# Diskette Drive Modifications

# TEAC 55A, 55B, 55C, 55D

# OKI 3305HU

# QUME Qumetrak 142

C23

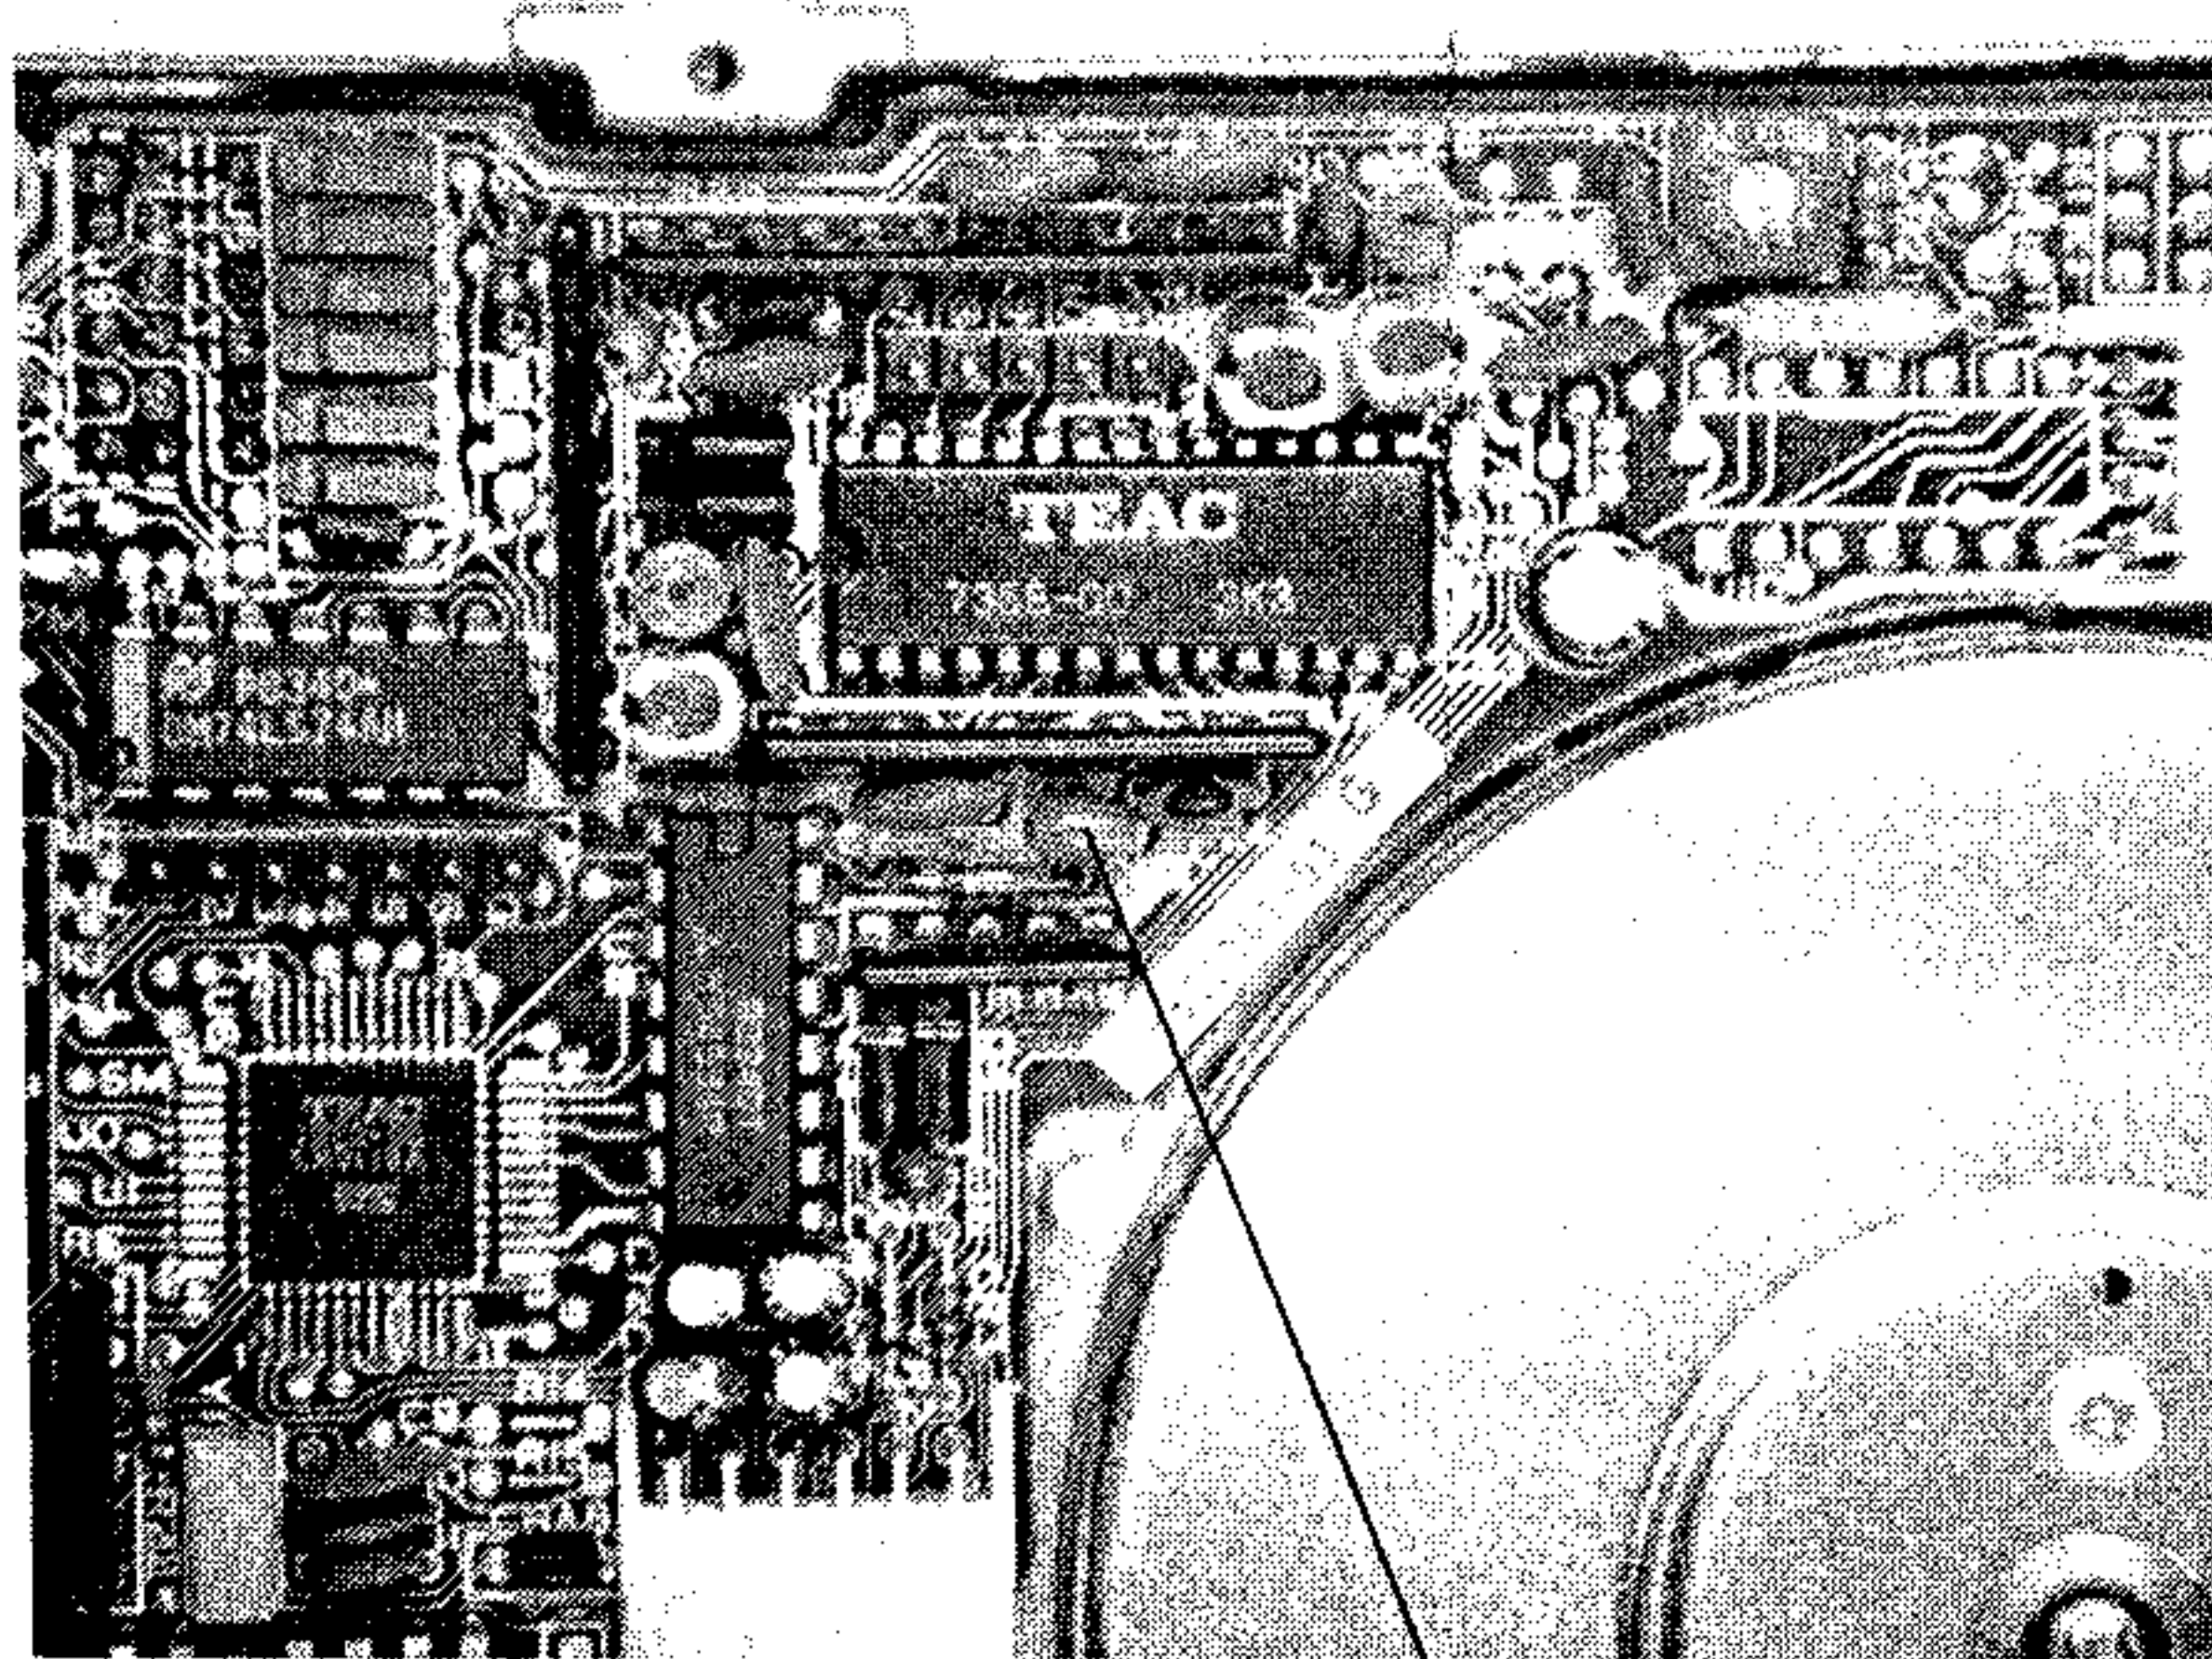
- 2) Locate capacitor C23 on the drive electronics board. The next photo shows C23 and the surrounding components.

C23

- 3) Carefully remove the drive electronics board from the drive chassis.
- 4) Remove C23 and replace it with a 140 pf capacitor.
- 5) Install the drive electronics board back in the drive chassis.

New Capacitor

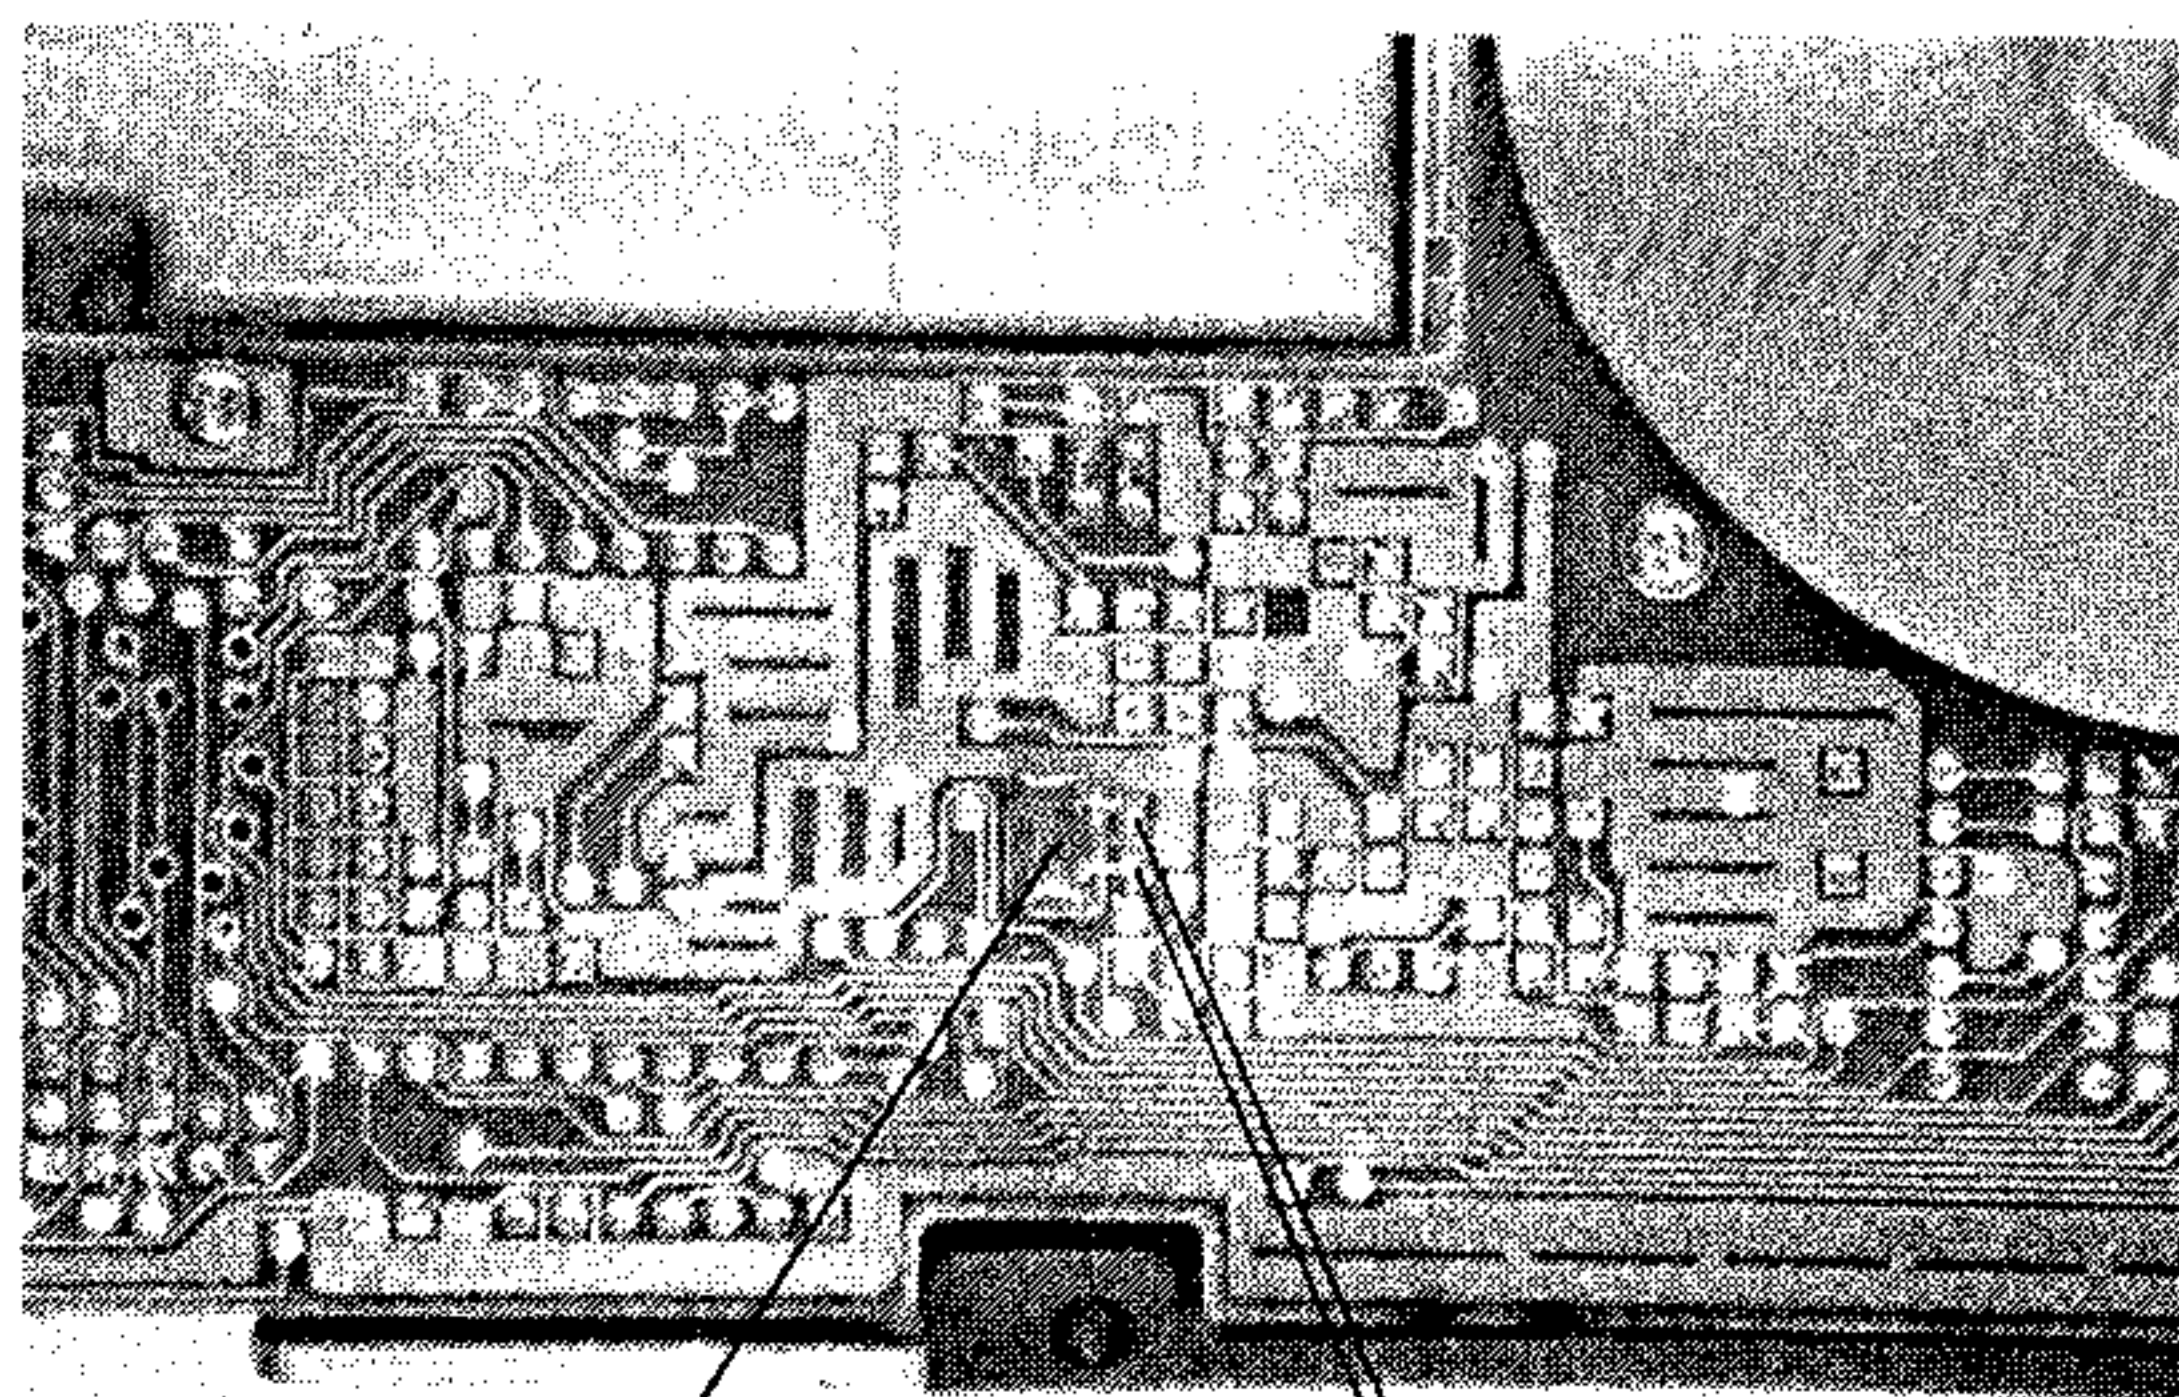
- 2) A 240 pf capacitor must be soldered to the drive electronics board. Use the following photo to locate the area where the capacitor is connected. The capacitor leads are soldered to the two pads just to the right of the new capacitor. Use the next photo to locate the proper position.

New Capacitor

Solder leads here
